6300204 CONDUIT  
COMMENTS FROM INTERNAL/INDUSTRY REVIEW

Comments: (8/9/22, Industry)

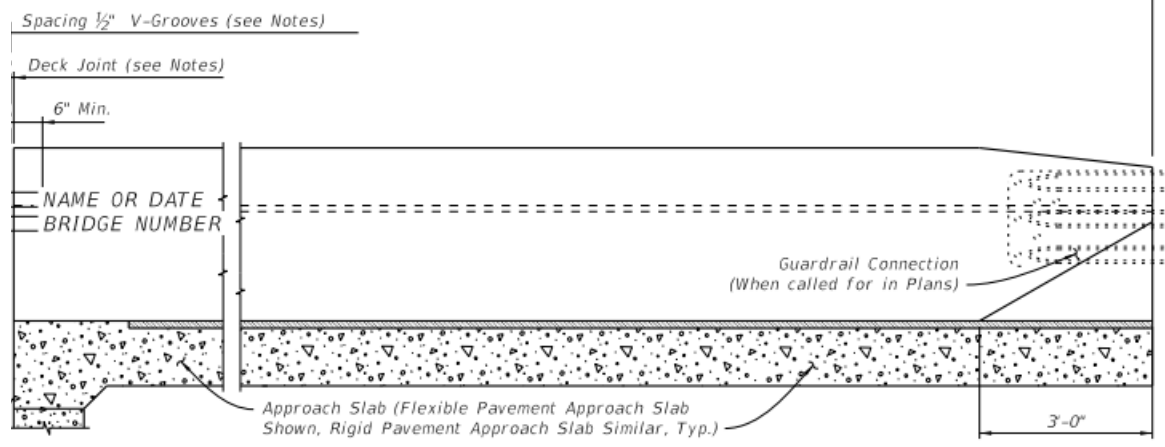
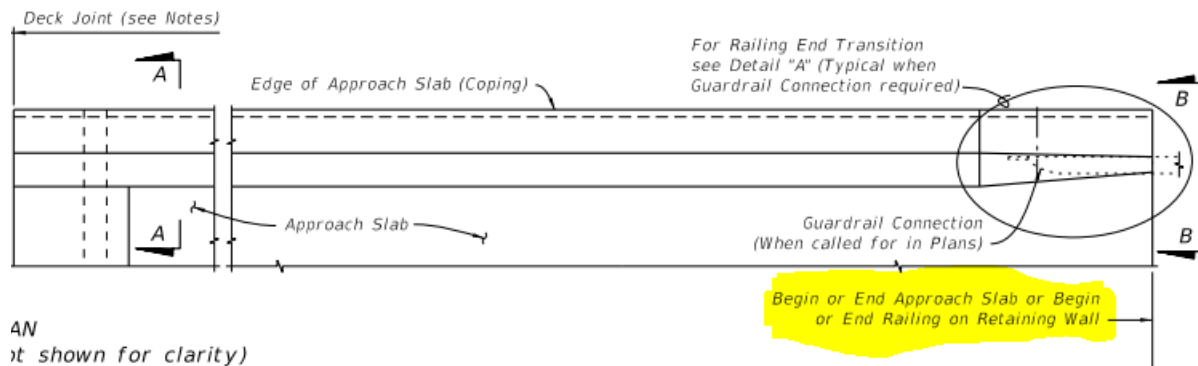
>> "Our discussion was always about the fact that the payment measurements ended at the pull box which is generally 6' from the end of the bridge but the conduits went the full length of the approach slab (+/-) before terminating."

Understood. Perhaps the confusion comes from not yet seeing the new Standard Plans, Index 630-010. We will be adding a clarifying statement seen below.

The end of rail and the end of approach slab for new construction will be the same. All current Standard Plans for bridge rail already shows Begin or End of Approach Slab coinciding with Begin or End of Railing.
